SERVICE BULLETIN

NACELLE - EXHAUST - THRUST REVERSER ATTACH HARDWARE AT NO. 4 HINGE LOCATION -
REPLACEMENT OF - CATEGORY CODE 4 - MOD.NAC-78-0016

V2500-NAC-78-0016

Repacement of No. 4 Hinge Hardware
Fig.1

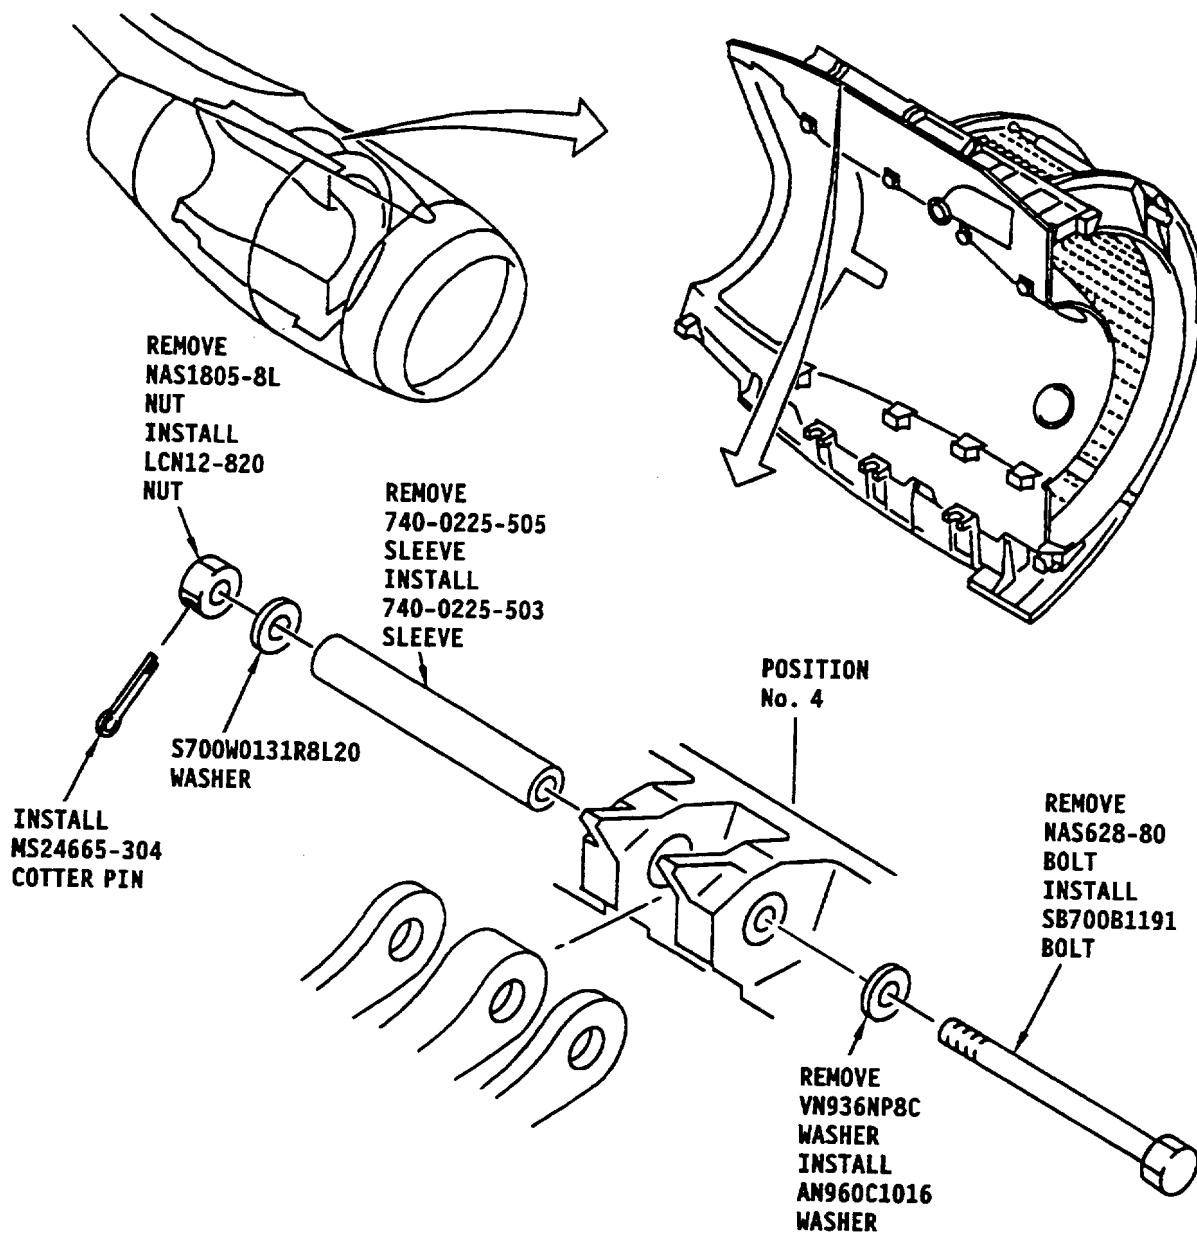
The existing No. 4 hinge bolt thread protrusion from the nut is not adequate, and there is a possibility that the hinge hardware may clamp up on the hinge lugs

To insure that the No. 4 hinge hardware cannot clamp up on the hinge lugs and to provide the correct bolt thread protrusion from the nut.

Replace the existing hinge hardware with new hardware including a longer bolt which is drilled to accommodate a castellated nut and cotter pin.

- (1) Remove bolt, washers, sleeve, and nut from No. 4 hinge. discard all hardware. (Refer to Figure 1).
- (2) Lubricate S700B1191 bolt with CoMat 10-058 penetrating oil.
- (3) Install 740-0225-503 sleeve, AN960C1016 washer, S700B1191 bolt, S700W0131R8L20 washer, and LCN12-820 nut.
- (4) Torque nut to 480 -690 lb-in. (54.2 -78.0 N.m).
- (5) Install MS24665-304 cotter pin in bolt.
